PLANNING REPORT

Architectural Review Board

83 S. Riverview Street 25-048 Informal

Address	83 S. Riverview Street, Dublin, Ohio, 43017
Proposal	House addition on a .25-acre lot in the Historic District.
Request	Informal review and feedback.
Zoning	HD-HR, Historic Residential District
Planning Recommendation	<u>Consideration of the discussion questions.</u>
Next Steps	Upon receiving feedback from the Architectural Review Board (ARB), the applicant may incorporate the feedback and submit for Minor Project Review.
Applicant	Geoffrey and Melissa Hahm, Owners Kara McCoy, Simplified Living Architecture + Design
Case Manager	Sarah Tresouthick Holt, AICP, ASLA, Senior Planner (614) 410-4662 sholt@dublin.oh.us

Site Plan Option 2, (1 story) with larger footprint

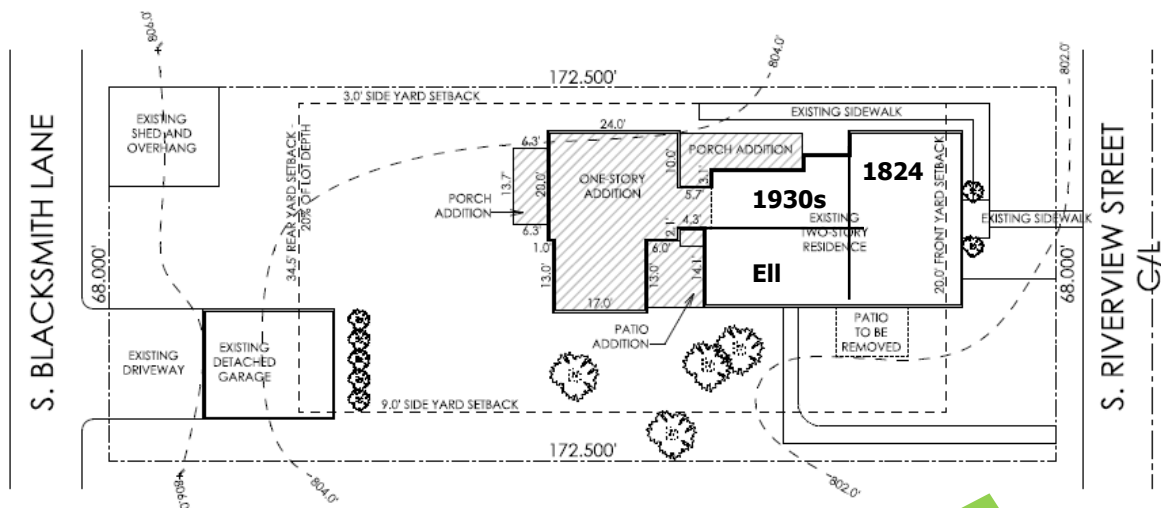
Based on discussions with the owner, simplified sketches were provided as Option 2. This layout covers slightly more of the lot than Option 1. The porch addition on the north side is pulled back from the original house, and the roof angle is lowered. The shape and proportions repeat the form of the original house and historic ell. Thus, a number of the previous proportionality concerns are addressed here. Specific comments include:

- The addition's height is the same as the kitchen ell on the south and north elevations, although it reads differently on other elevations. The addition height should match, or be lower than, the ell's height
- The hyphen is not readily discernable here, contrary to Guidelines 4.12A and D
- The eaves of the addition should match the same on the kitchen ell
- The column/door conflict on the north elevation should be better aligned, and the three columns spaced evenly
- The west elevation's porch and window alignments should be centered in the gable
- The illustrative elevations show a complex variety of siding materials

North Elevation, Option 1

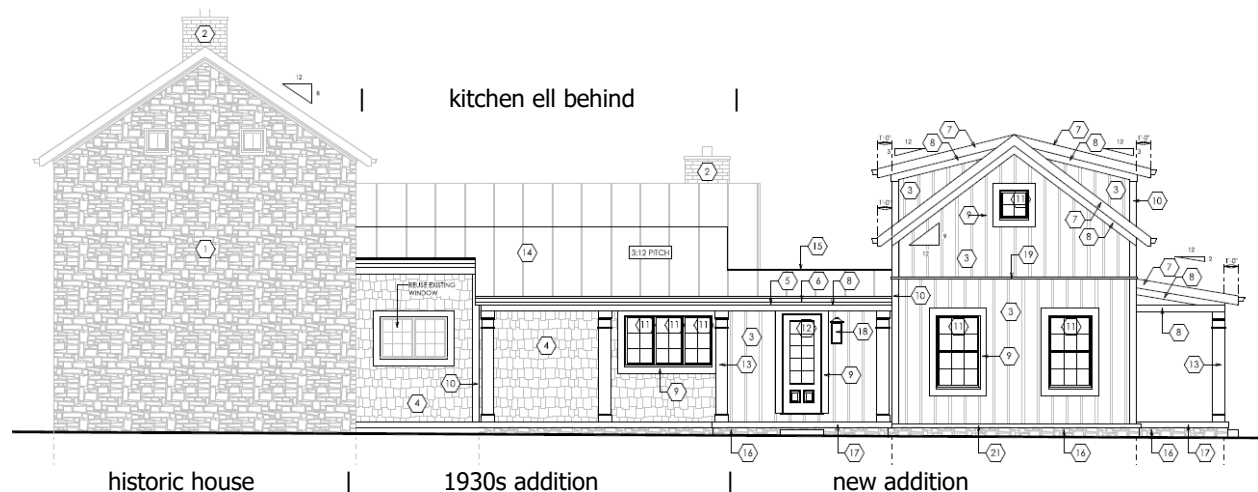
Staff has met with the applicant and expressed concerns with this option. As discussed at the demolition request in November 2024, the 1930s addition does not meet today's Code and Guidelines: it hides original fabric, its width is close to the original house's, the style is different, and the roof form is very different. The home owner's goal is to avoid disturbing the foundation of the original house by keeping the 1930s addition, while also addressing a leaking flat roof. These are understandable goals; however, the resulting new taller/longer roof form appears to cover an upper story historic window ("faux panel" on rear elevation), additional historic stonework, and a significant portion of the ell's roof, contrary to Guidelines 4.12D. A flatter roof could solve these issues, while still being weather-tight.

The proposed north porch addition is cut back from the historic house, creating a complicated roof shape not related to the original structure or ell. The porch is heavy in appearance and not sympathetic to the style of the original house. These conditions are in conflict with Code §§ 153.173(E)(2)(b) and (c) and Guidelines Section 4.12. The Pennsylvania Historic & Museum Commission (<https://www.phmc.state.pa.us/portal/communities/architecture/styles/federal.html>) notes that Federal buildings' identifiable features include "*classical* details, similar to the Georgian style, but *more delicate in size and scale*" (emphasis added). The hyphen at the new addition is readily discernable, per Code and Guidelines.

The proposed renovation of the 1930s addition shows horizontal window forms that are not meeting Code § 153.174(D)(5) and Guidelines Section 5.6A, B, and C. Since this addition is built of CMU, and therefore modular, vertical window openings are possible with these renovations.

Rear/West Elevation, new addition, Option 1

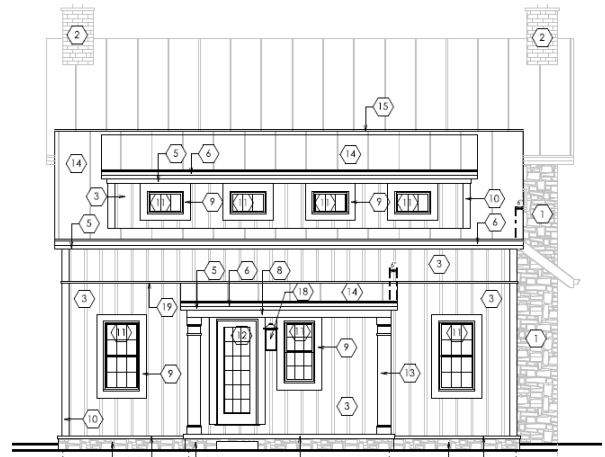
Option 1's addition has proportionality concerns: it is small and upright, based on a desire to leave maximum yard area. Staff suggested:

- Using the proportions of the original house as a guide
- Possibly using more height, if balanced with the overall size of the addition, or conversely removing the second floor and relocating the storage area (see Option 2).

- Avoiding the 45 degree gable pitch (*Get Your House Right, Cusato and Pentreath, page 191*), and using the pitch on the historic building, per Guidelines 5.3B

- Avoiding the horizontal windows on the shed dormer, and square windows in the gables, which do not meet Code § 153.174(D)(5)
- Setting the shed dormers back from the main façade of the house (*Get Your House Right, page 120*)

- Ensuring window and door alignments are symmetrical per Guidelines 5.6A
- The owner, applicant, and staff had meetings to go over these concerns, and it was encouraged that loose sketches be used to determine best massing, shape, and forms, rather than the fully-rendered drawings used for this option (see Option 2).
